May 8, 1986

REF: Consent Decree 80-73699

The following are the responses to questions raised in your letter of 31 March:

PROPOSED DESIGNATION SYSTEM - RIVERVIEW WELLS

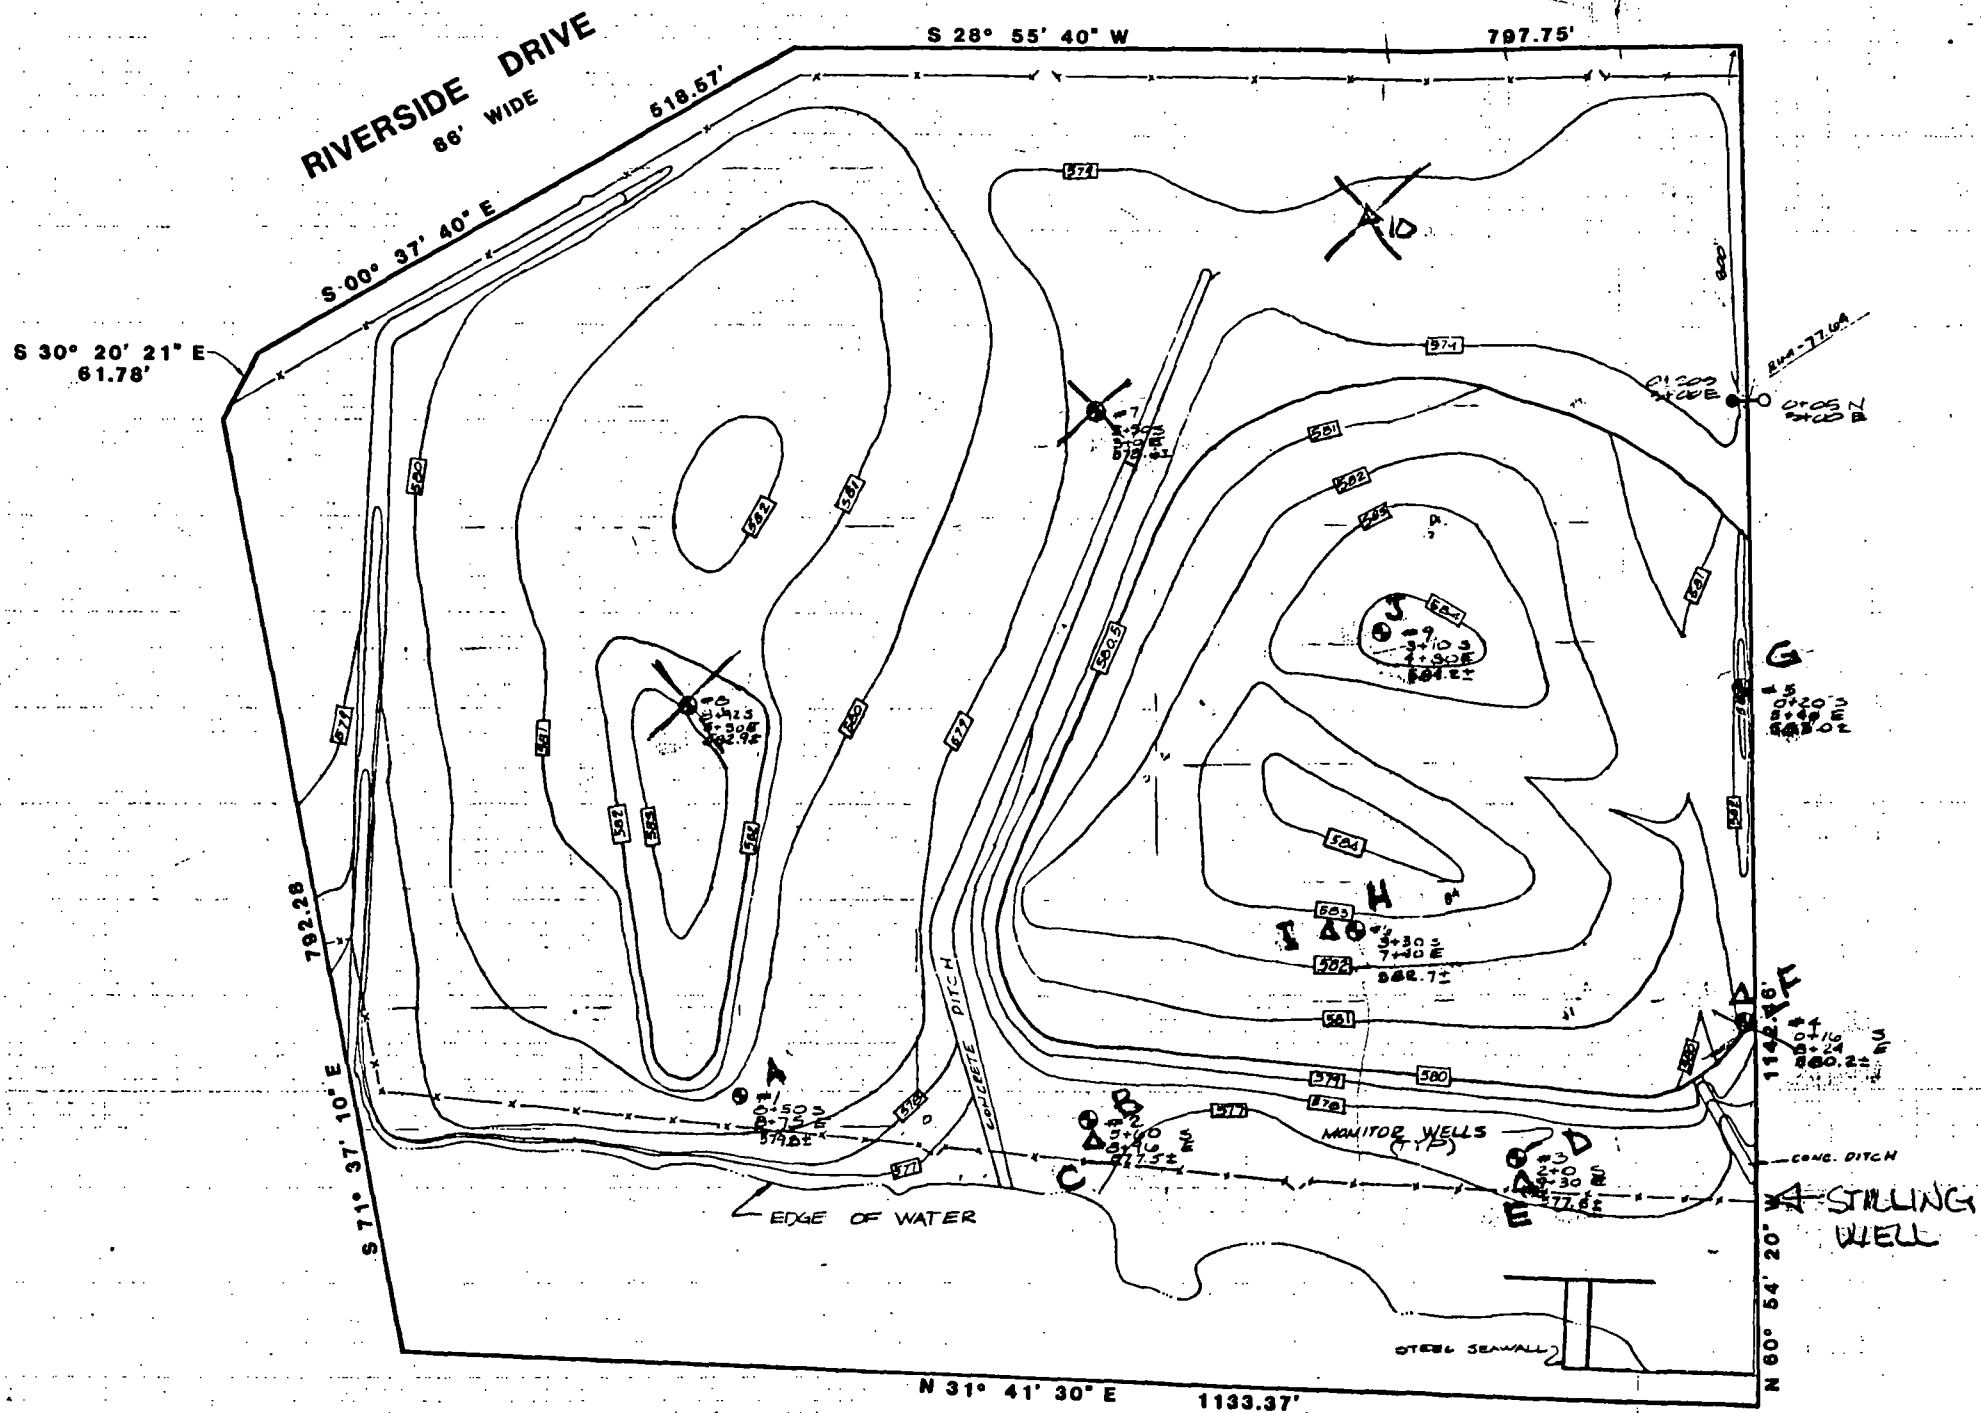
QUESTION 7: Numbering system discussion.

QUESTION 12: What are/were coordinates and elevations?

ANSWER: See proposed identification system herewith.

ANSWER: See data sheet (proposed identification system) herewith.

To avoid future confusion, we have created a new letter identification system for all active wells. The letter assigned is shown in the left hand column of the attachment.
